**SECTION 00 90 01  
BIDDING AND CONTRACT REQUIREMENTS  
ADDENDUM NUMBER (3)**

**Re: ADDENDUM NUMBER (3) TO THE BIDDING DOCUMENTS FOR**

**Peoria Park District  
Golf Entertainment Facility Renovation an Addition  
Architect's Project Number: 22-051**

**FIRST FLOOR PLAN -  
 RANGE BAYS -  
 LIGHTING**

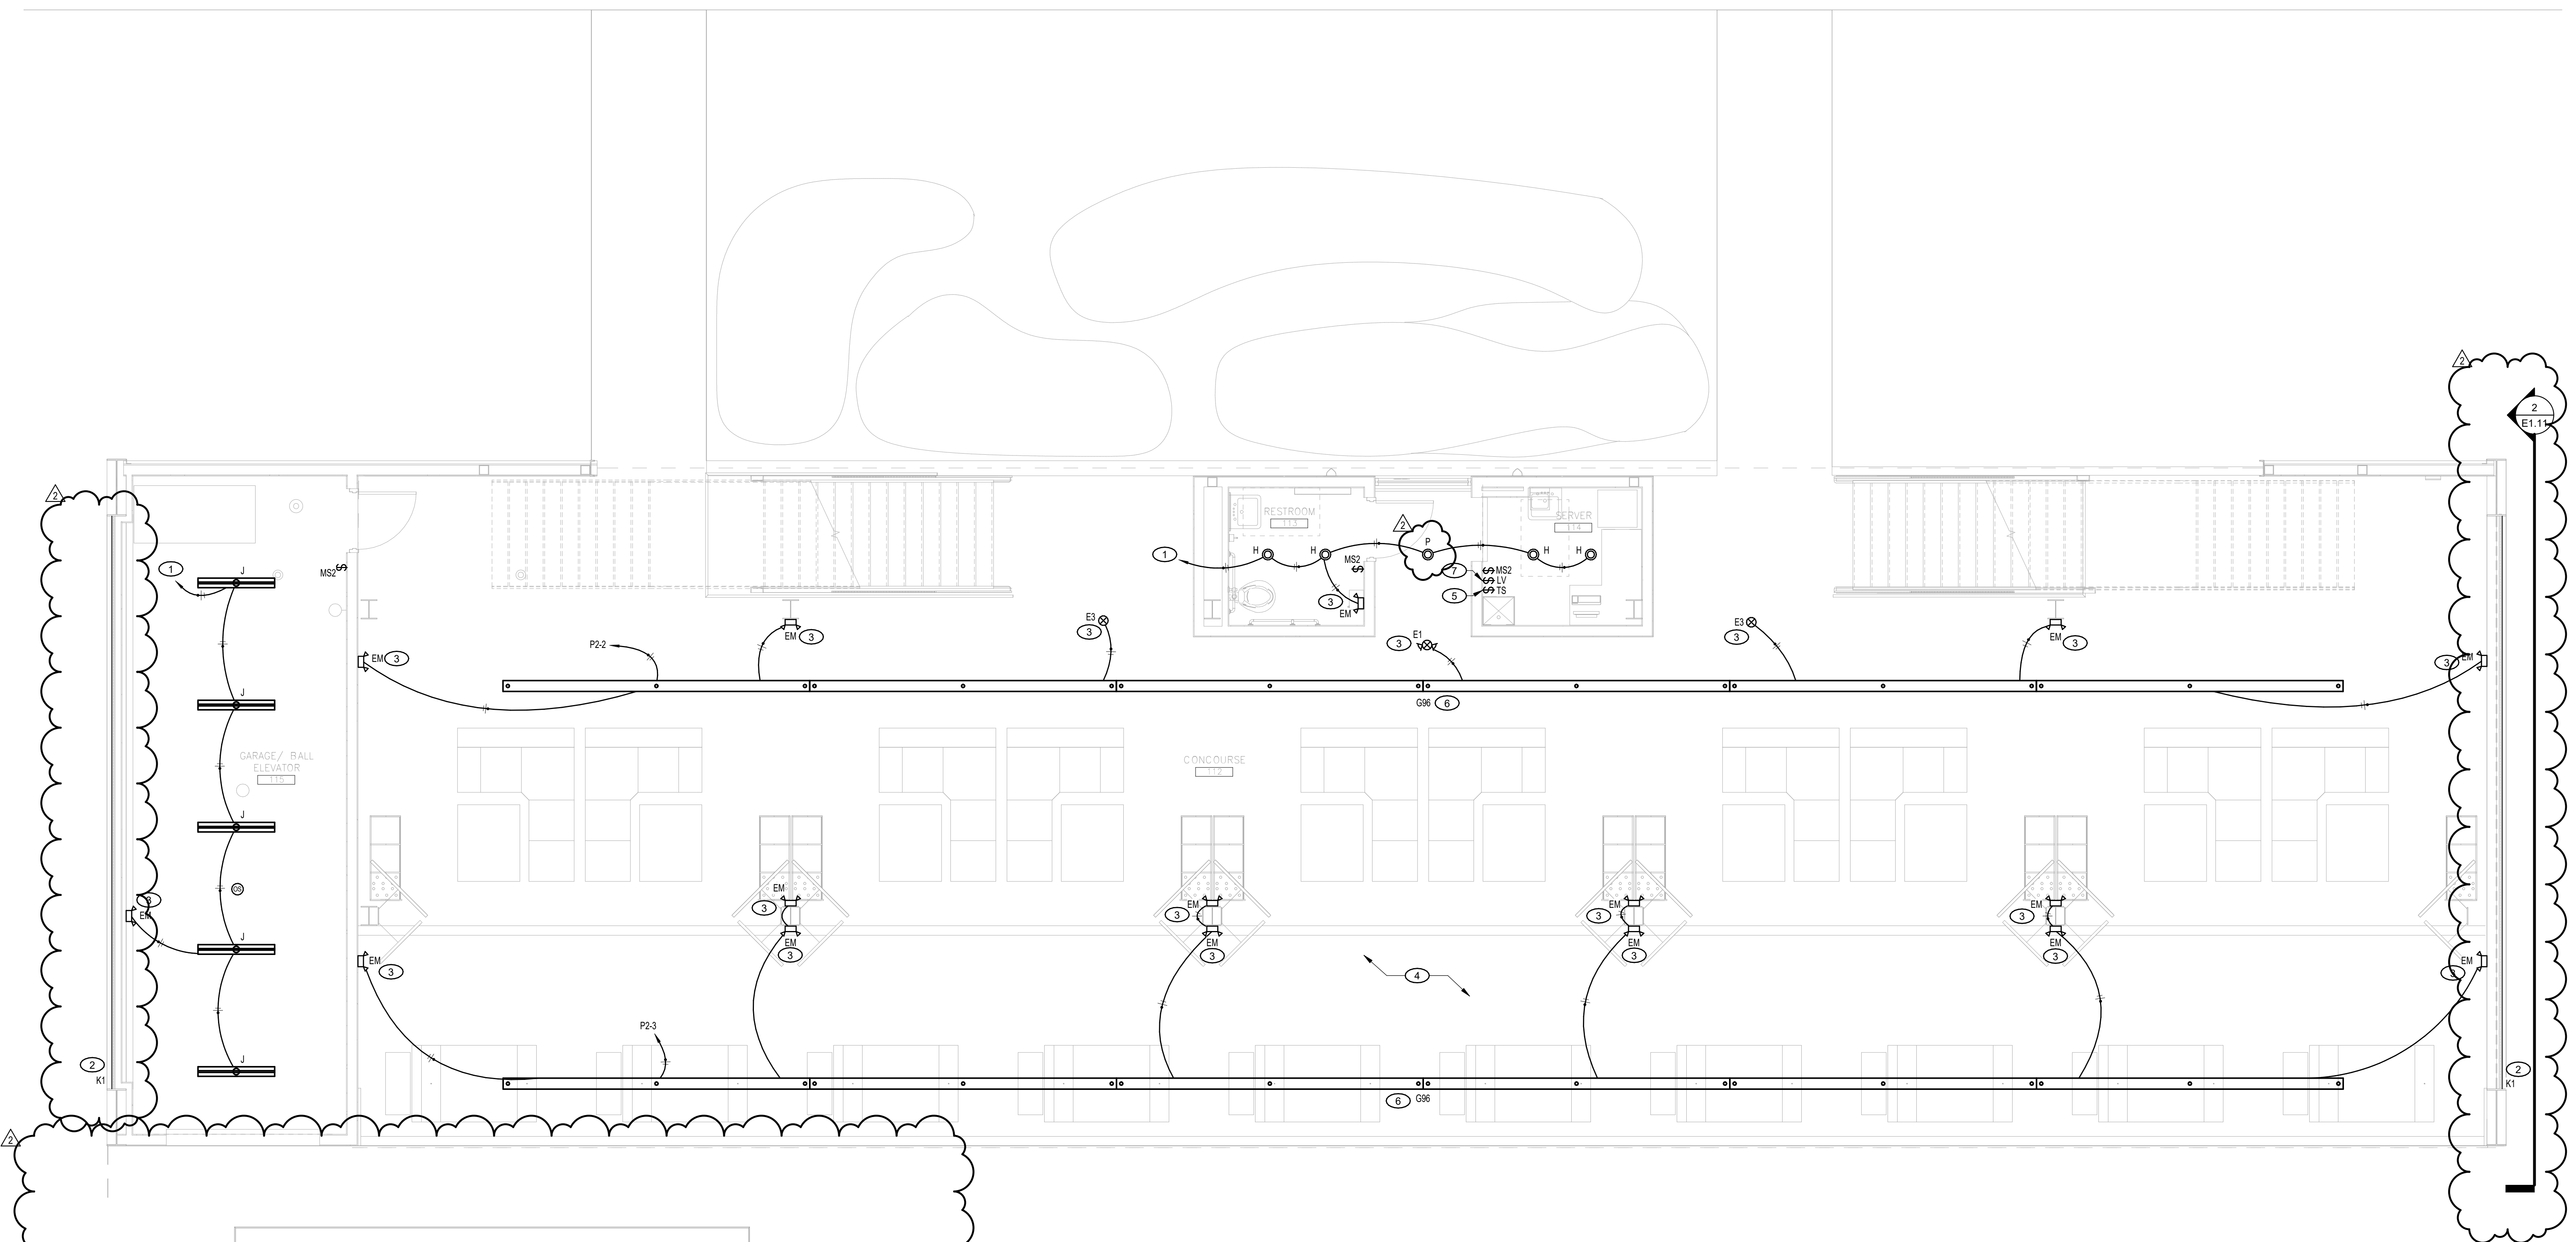
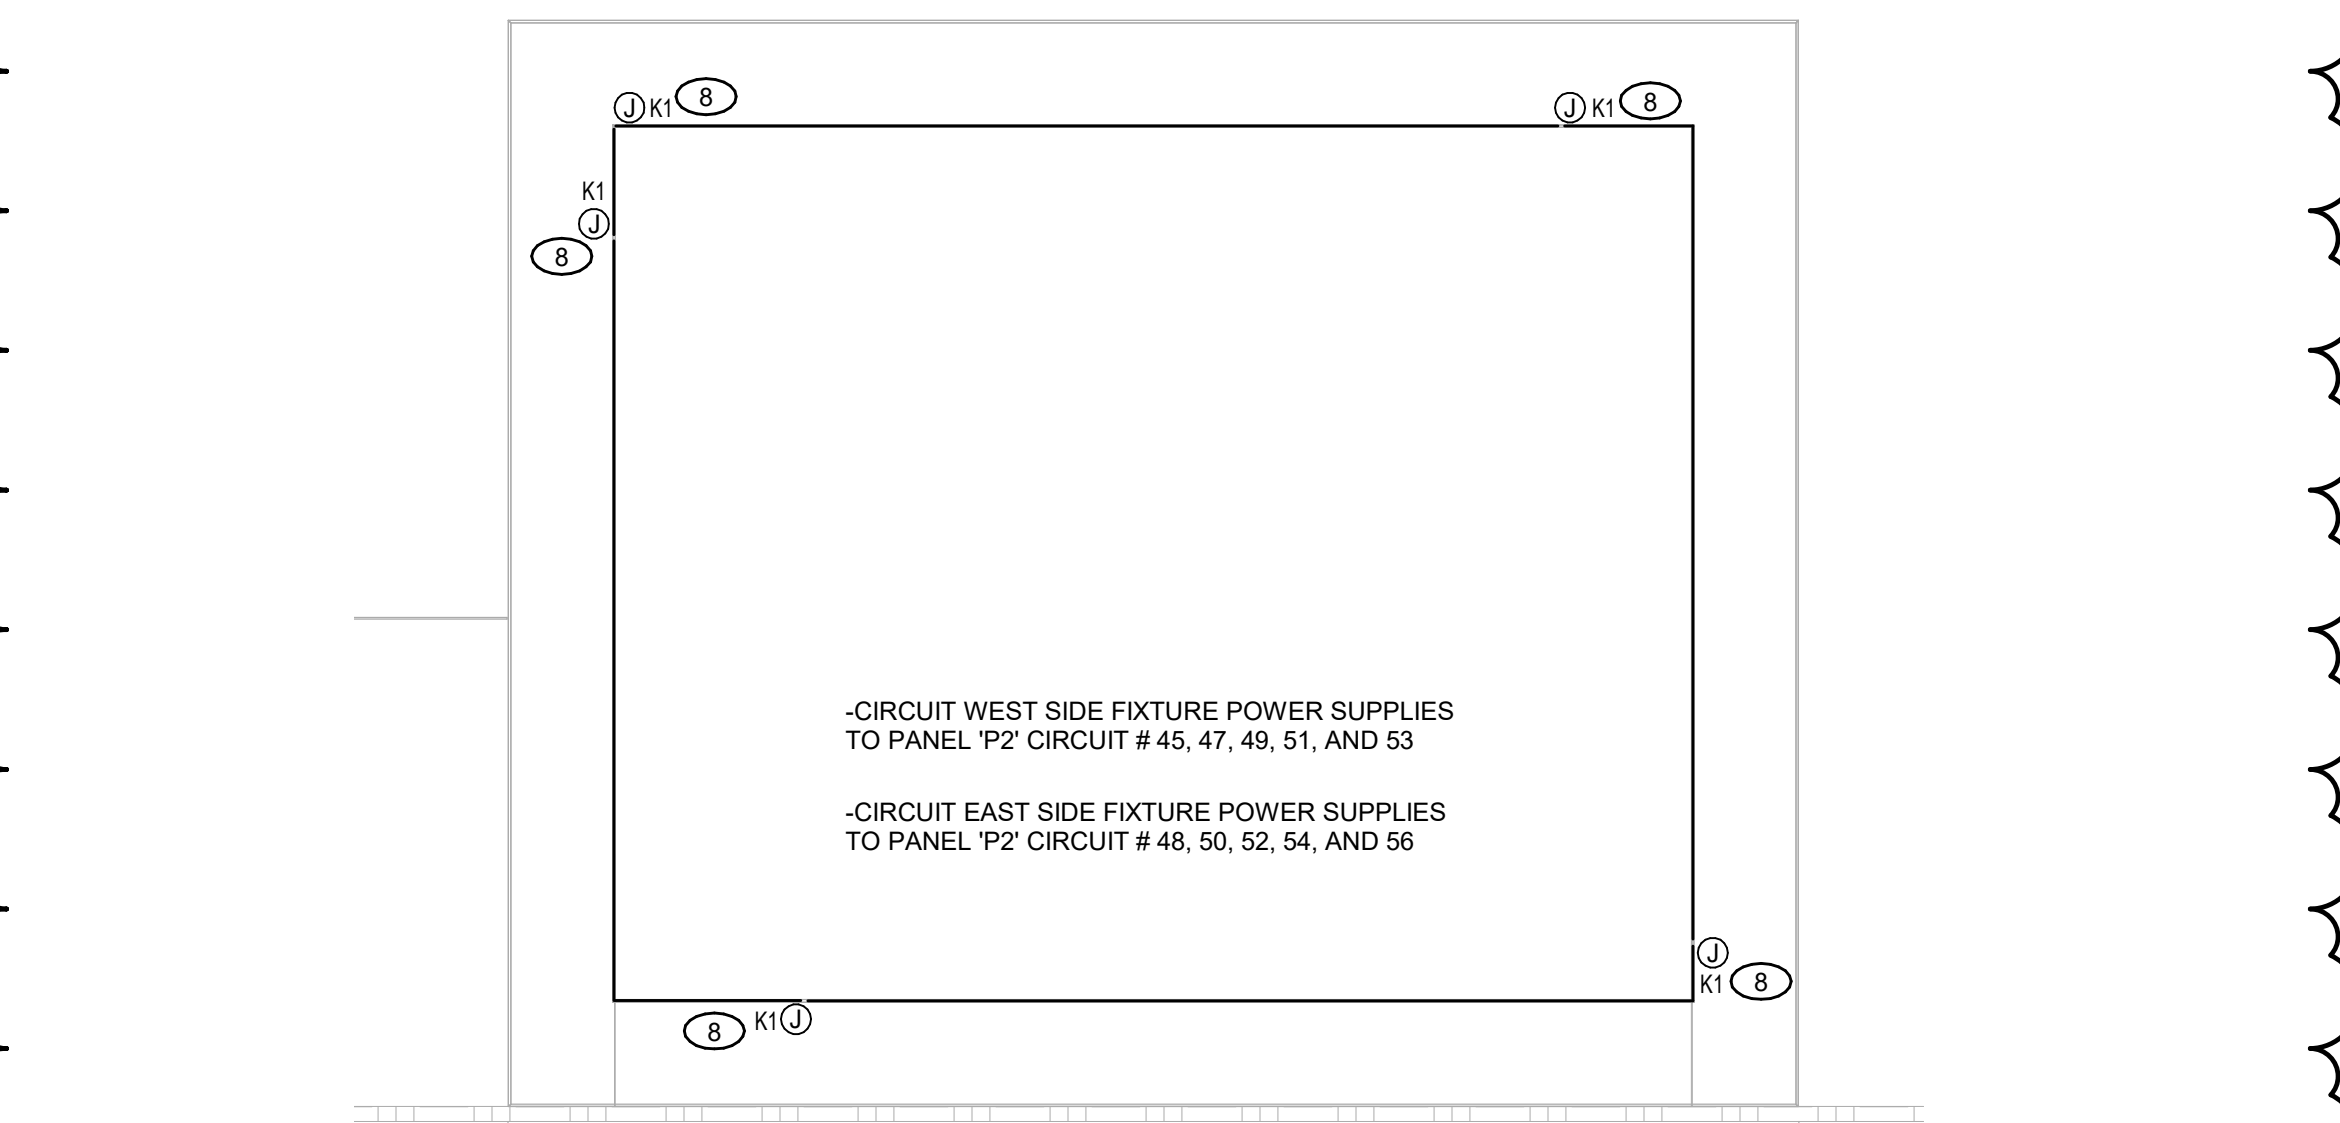
E1.11 and E1.21 – K1 LED strip appears to run vertically up the east and west ends of the south side and then horizontally along the south. A2.11 has notes about it running the perimeter of the east end. Can we review these plans to make sure they match?

2. Drawing E1.11 – FIRST FLOOR PLAN – RANGE BAYS - LIGHTING
  - a. Added fixture type 'P' for 6" cylinder pendant fixture in short corridor between restroom and server rooms. Coordinate mounting heights with architect prior to release.

- b. Revise LED tape light layout of fixture type 'K1'.
  - c. Revise keyed note #2 describing installation of fixture type 'K1' in framed openings on exterior walls.

- d. Add detail #2 for installation of LED tape light around framed openings to show power supply requirements and circuiting.
  - e. Add keyed note #8 for clarification of detail #2.

Lighting plans have been revised to show the led strip lighting around the wide flange "picture frame" Refer to architectural section details 1,2 and 3 on sheet A7.03 for additional clarification.

1. CIRCUIT CONTINUES TO NEXT FLOOR FIXTURES. SEE KEYED NOTE ON SHEET E1.21 FOR CONTINUATION OF CIRCUIT.
2. FURNISH AND INSTALL LED TAPE LIGHT IN CHANNEL ALONG WIDE-FLANGED FRAMED OPENINGS OF EXTERIOR WALLS ON SIDES OF BUILDING AS SHOWN IN DETAIL 2 ON THIS SHEET. REFER TO ARCHITECTURAL DETAILS FOR COORDINATION OF LED CHANNEL INSTALLATION.

8. EACH JUNCTION BOX SHOWN REPRESENTS A 24V POWER SUPPLY REQUIRED FOR LED TAPE LIGHT DRIVER POWER. EACH DRIVER WILL REQUIRE SEPARATE 120V CIRCUIT FED FROM PANEL 'P2' AS DESCRIBED IN THIS DETAIL.

SHEET TITLE:  
**SECOND FLOOR PLAN  
 - RANGE BAYS -  
 LIGHTING**

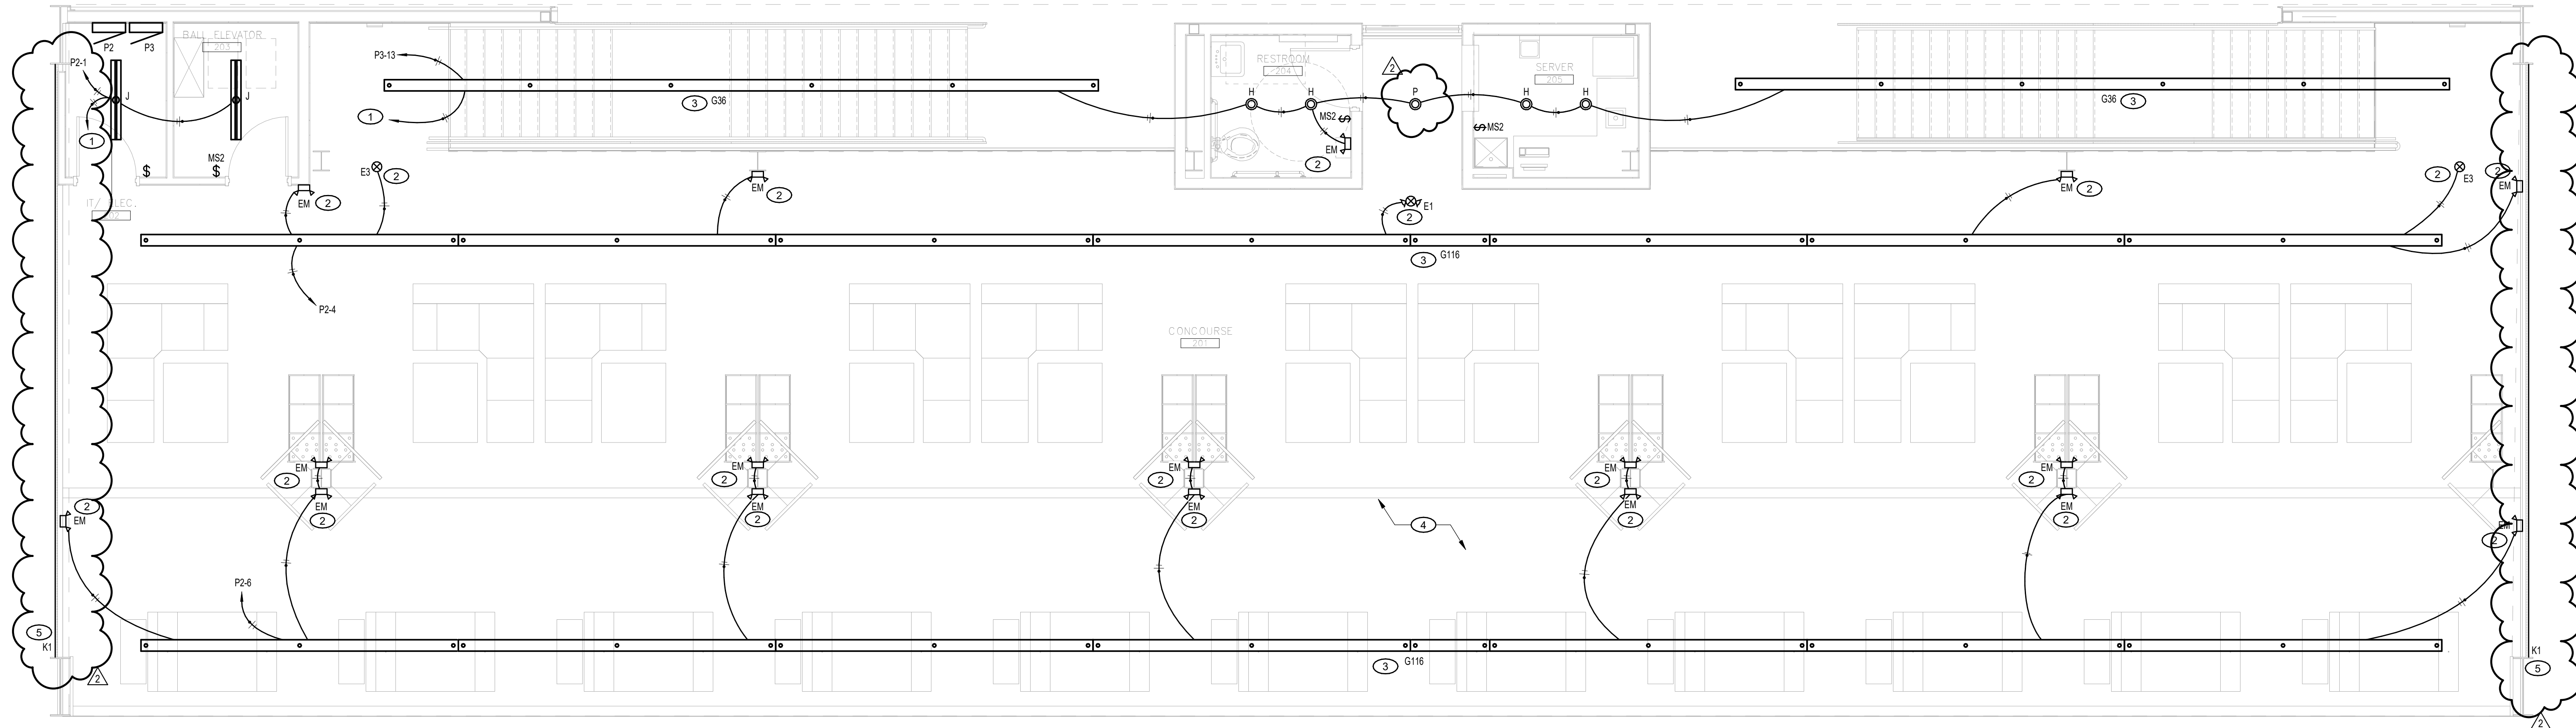
3. Drawing E1.21 – SECOND FLOOR PLAN – RANGE BAYS - LIGHTING
  - a. Added fixture type 'P' for 6" cylinder pendant fixture in short corridor between restroom and server rooms. Coordinate mounting heights with architect prior to release.

- b. Revise LED tape light layout of fixture type 'K1'.
  - c. Revise keyed note #5 describing installation of fixture type 'K1' in framed openings on exterior walls.
